ADDENDUM NO. 1

PROJECT NAME: *Marianna Iralena Hotel*

PROJECT NUMBER: *FLORIDA COMMERCE: CDBG-DR M0047*
DHM PROJECT NUMBER: *MAR22HR*

1. This Addendum is posted on the OneDrive link under Addendum & RFIs > Addendum #1. The OneDrive link is the original link containing the Plans & Specifications. If you do not have the link, please request the link from martivickery@melvineng.com.
2. RFI are listed on the OneDrive link and are constantly updated.
3. A revised Bid Tabulation Detail sheet C-410 Page 2 of 6 is attached and shall be used with the bid submittal.
4. A Conflict of Interest form was missing from the specs and is attached.
5. The asbestos and lead paint report is attached for reference. All asbestos has been removed. Lead paint does remain in the building and the contractor shall mitigate lead paint issues in accordance with local, state and federal requirements.
6. Attached are Donofro Addendum 1 items.
7. Attached are revised plan sheets A-0.1, A-1.1, A-1.2, A-1.4, A-2.0, A-3.0 and A-8.0.

ALL TEST RESULTS PERFORMED ON (2) COATS GRANITOL APPLIED @ 300-350 SF/GAL. & 14-DAY CURE @ 77° F & 50% R.H.

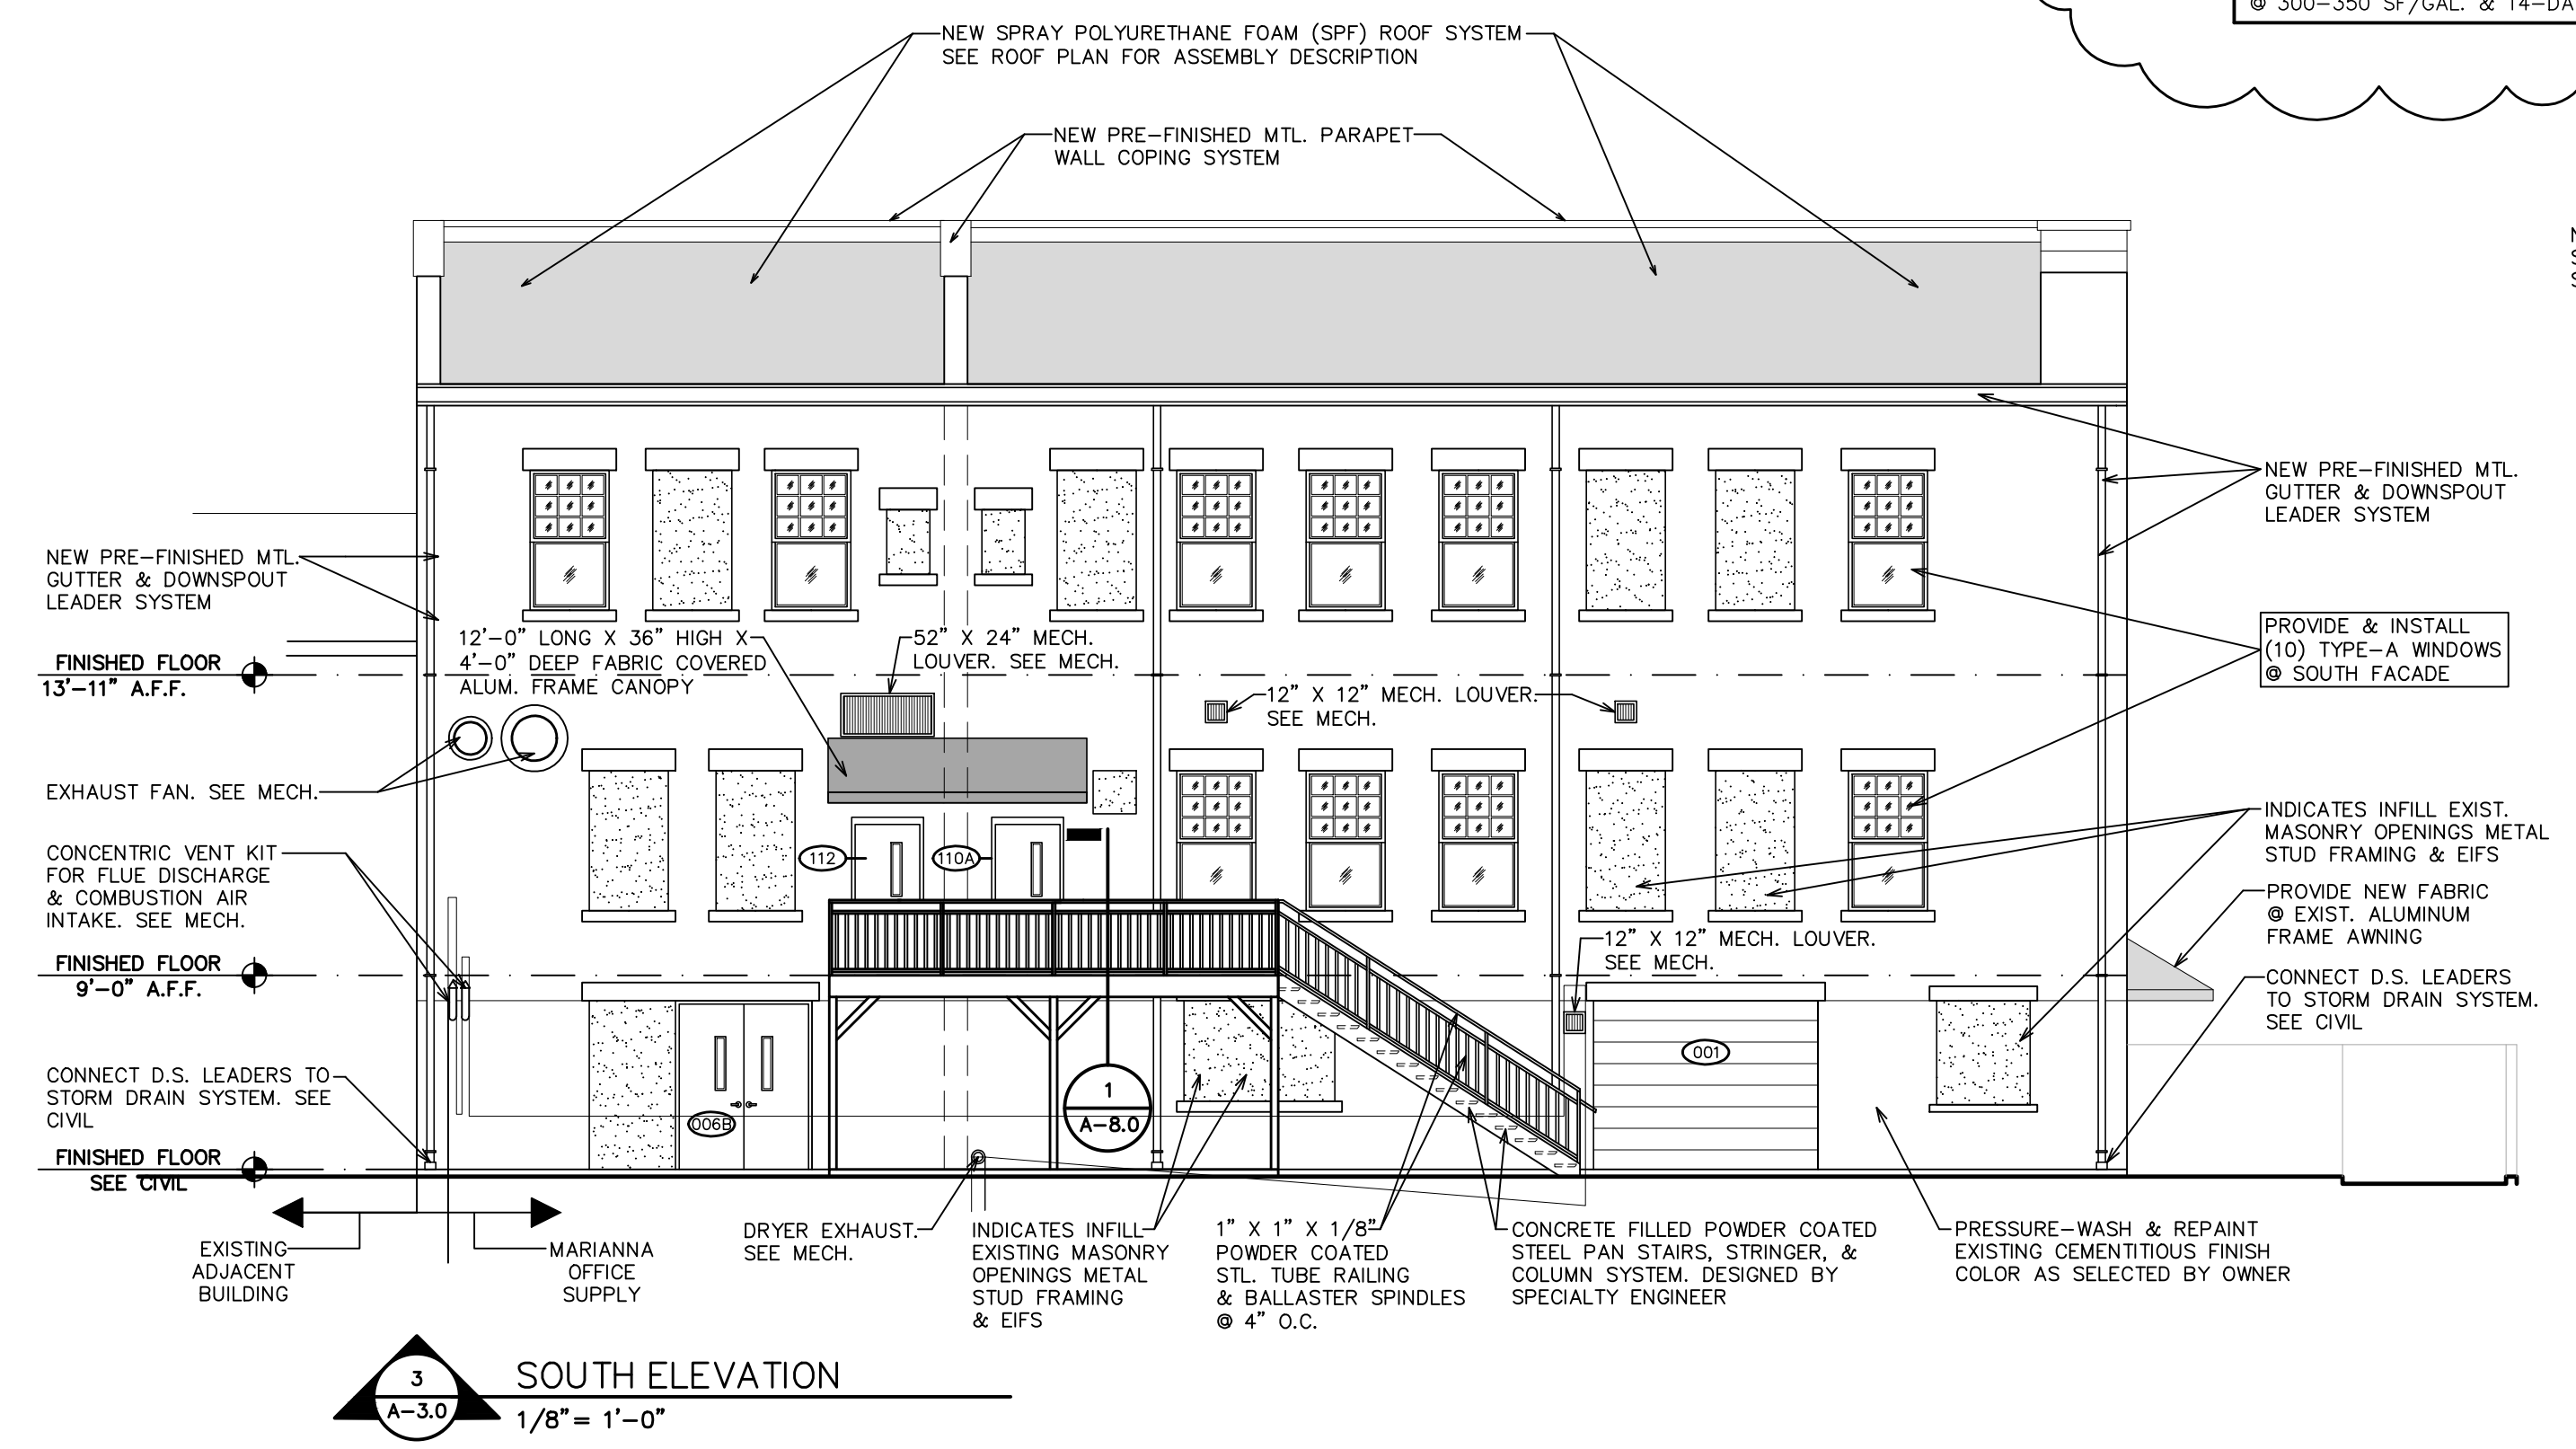
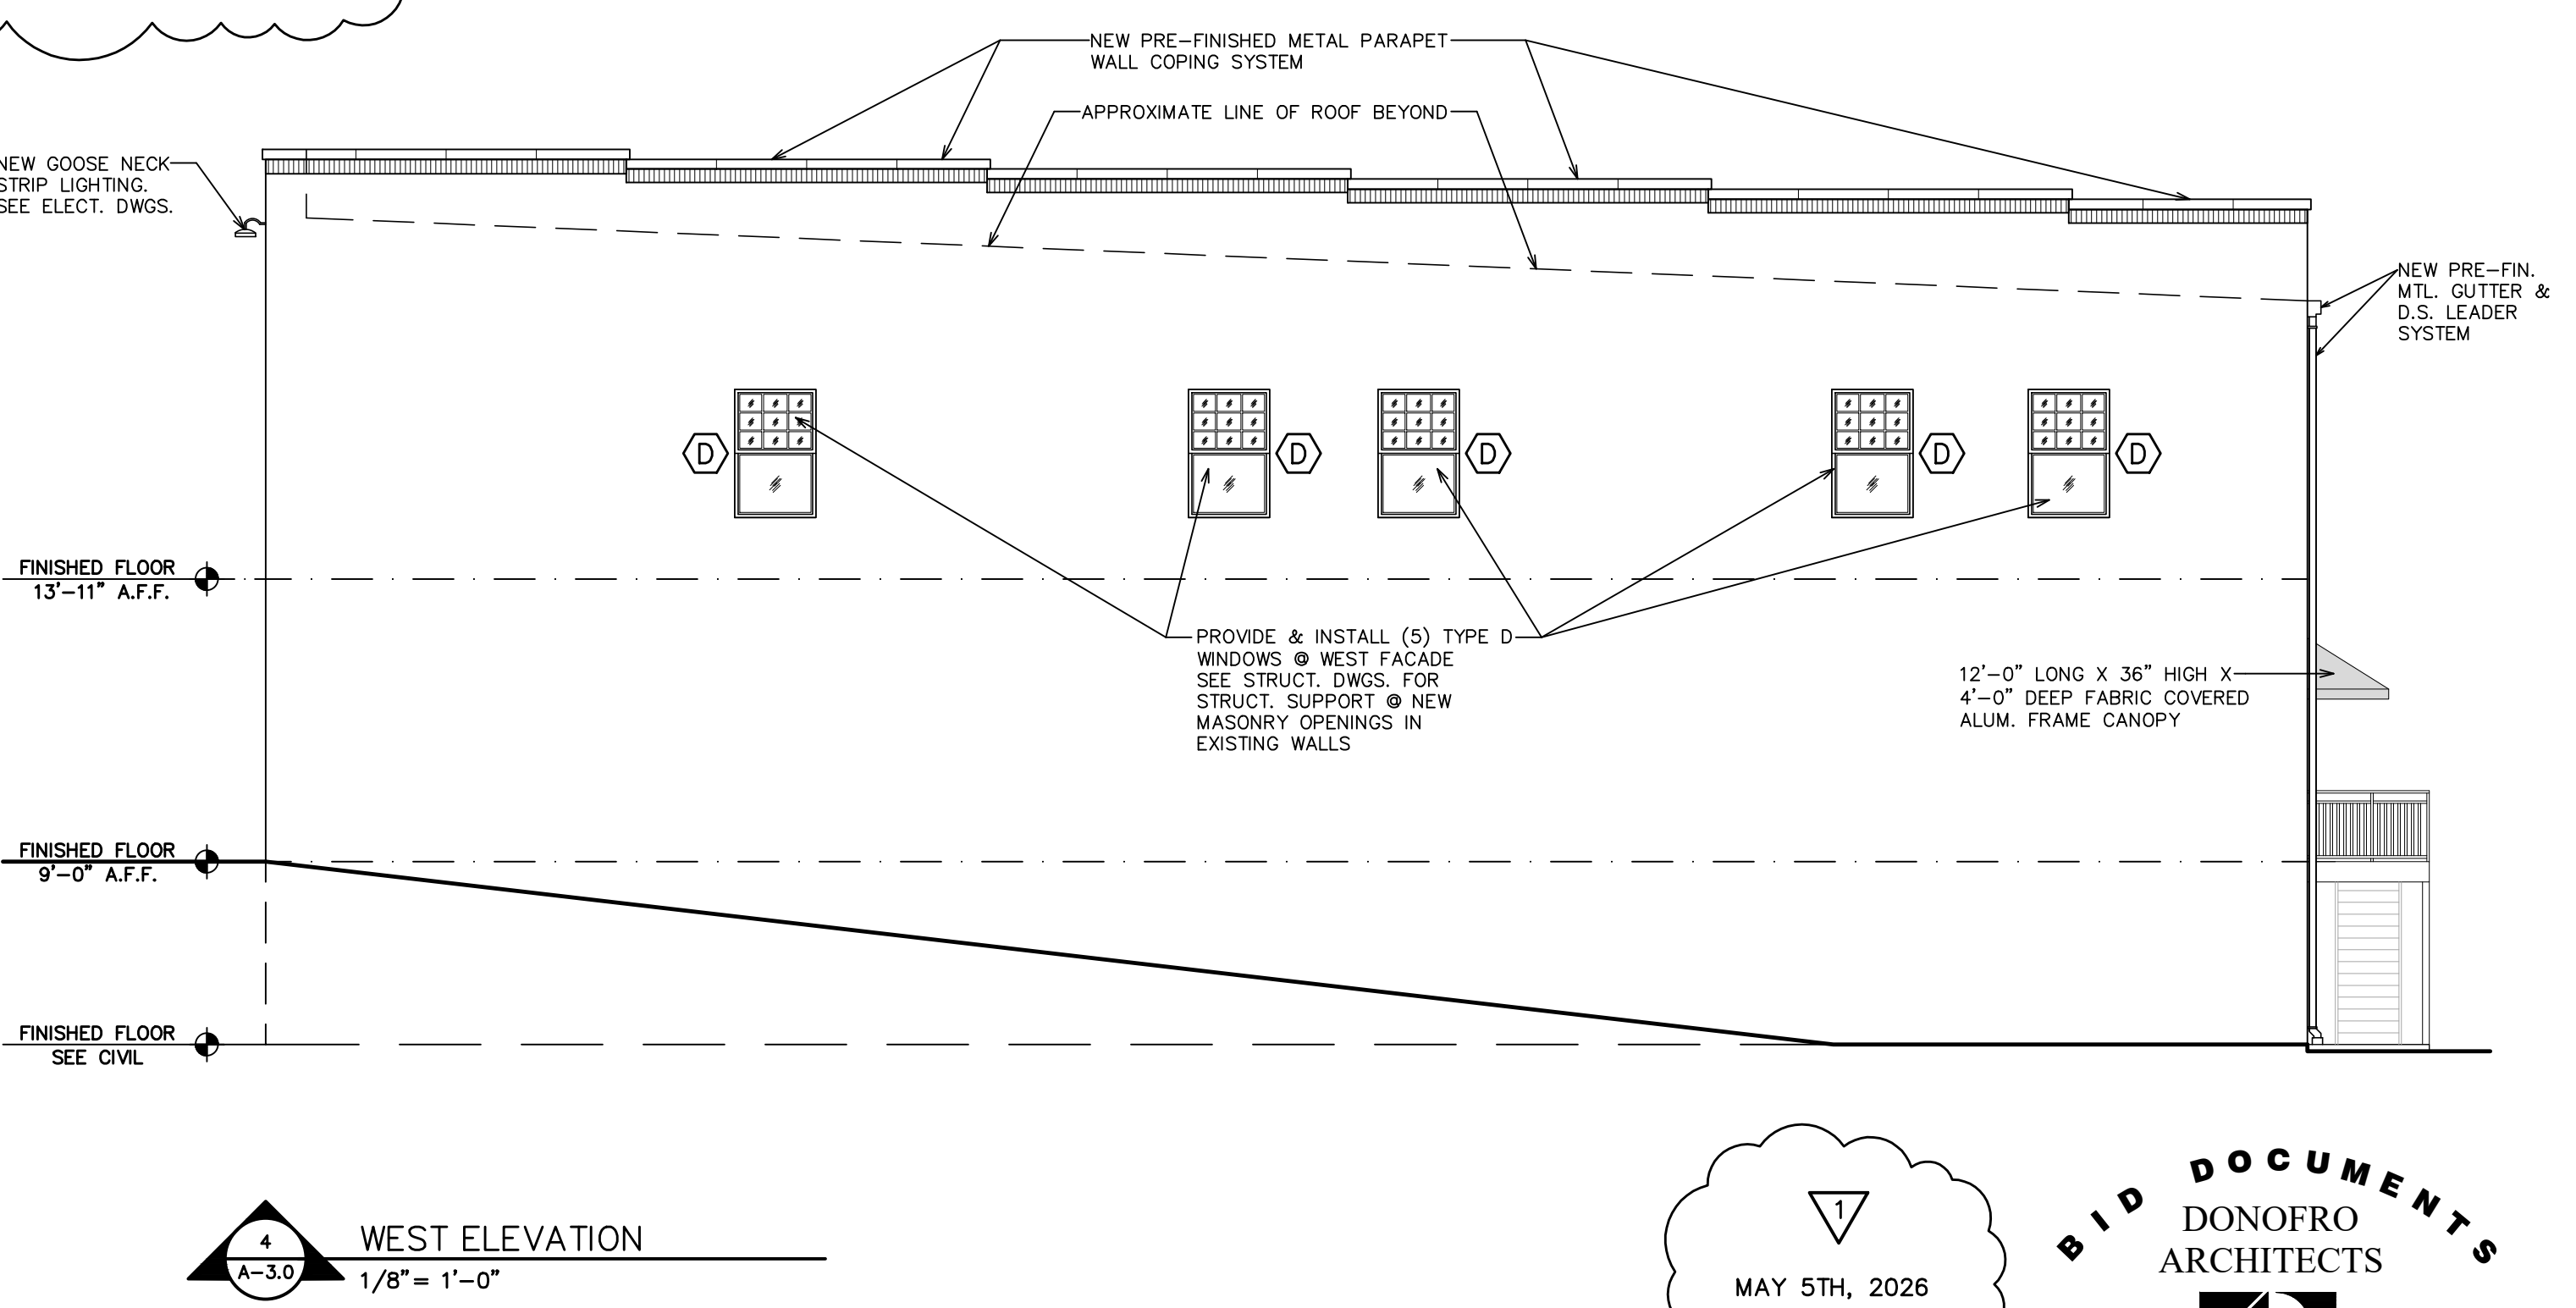
<p>Item 4: 5-04-2026</p>	<p>Refer to Architectural Sheets A- 2.0 and A -2.1</p> <p>ADD add the following Note.</p> <p>EXISTING INTERIOR BRICK SURFACES - All existing interior brick surfaces to remain and to remain exposed and shall receive a minimum two coat application of clear, matte, water based polyurethane sealer. Application of the sealer to achieve a natural, matte finish and to exhibit no visible sheen nor yellowing. Contractor to apply product to a 3' x 3' (minimum) test area for owner review and approval prior to full application. All surfaces to receive sealer application shall be clean, dry and free of dust, loose mortar, and efflorescence prior to sealer application. See revised sheet A-2.0 and A-2.1 included with this addendum.</p>
<p>Item 5: 5-04-2026</p>	<p>Refer to Shet A-3.0</p> <p>ADD the following note:</p> <p>The entirety of the existing building exterior to be painted including but not limited to the existing face brick veneer, the cement stucco, concrete window headers, and C.I. pilasters using KEIM Paints. For painting the existing brick veneer and stucco surfaces use a minimum of two coats of KEIM Granital Exterior Mineral Potassium Silicate Paint at an application rate of 250 to 300 sf per gallon. Prior to paint application, existing surfaces to be repainted shall be thoroughly cleaned, dry and prepared as per KEIM Paint Manufacturer's recommendation. See revised sheet A-3.0 included with this addendum.</p>

5A HEAD DETAIL
1\"/>

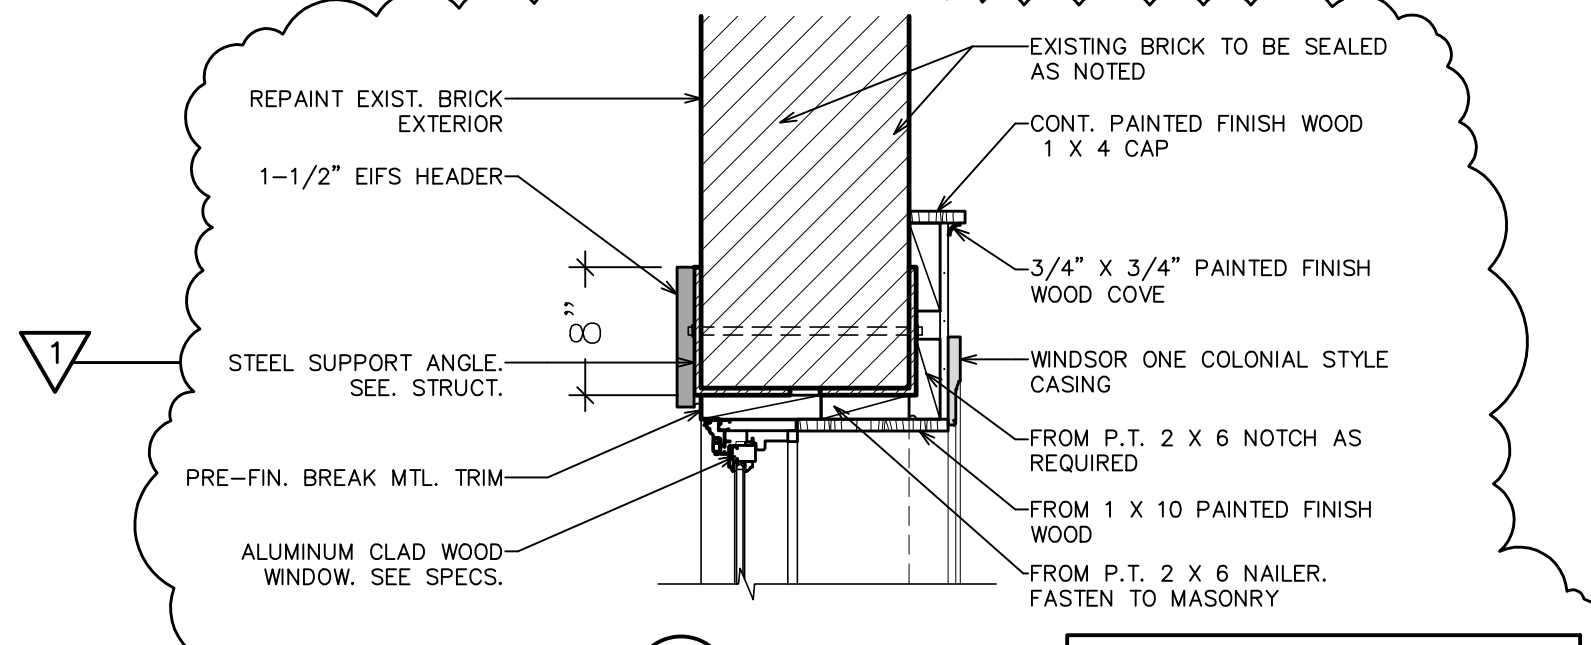
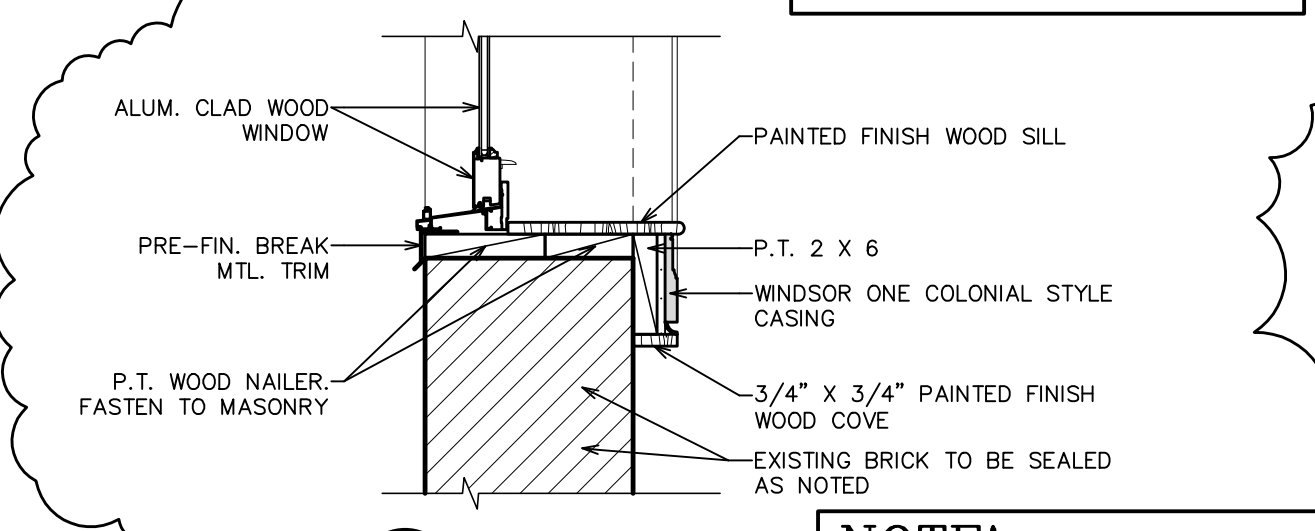
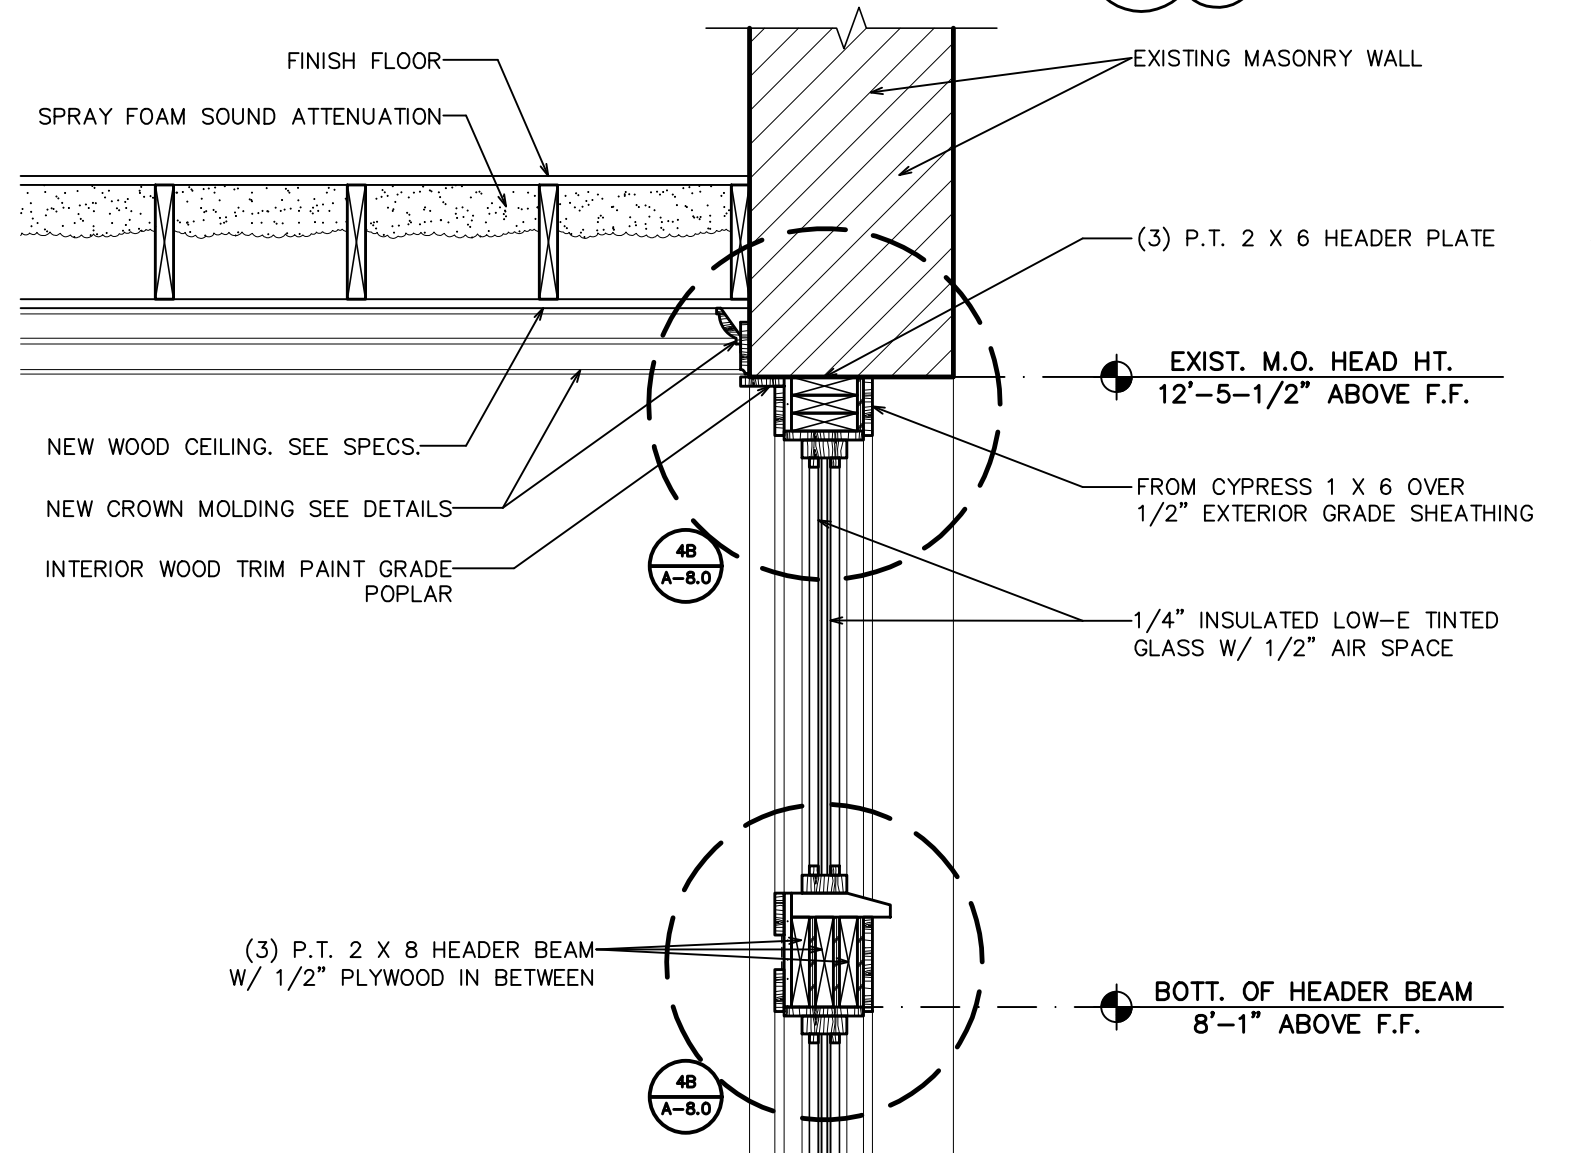
Item 6: 5-04-2026	Drawings, Sheet A-8.0 See revised sheet A 8.0 included with this addendum that includes typical window head and sill details 5A - A-8.0 and 5B - A-8.0
-----------------------------	---
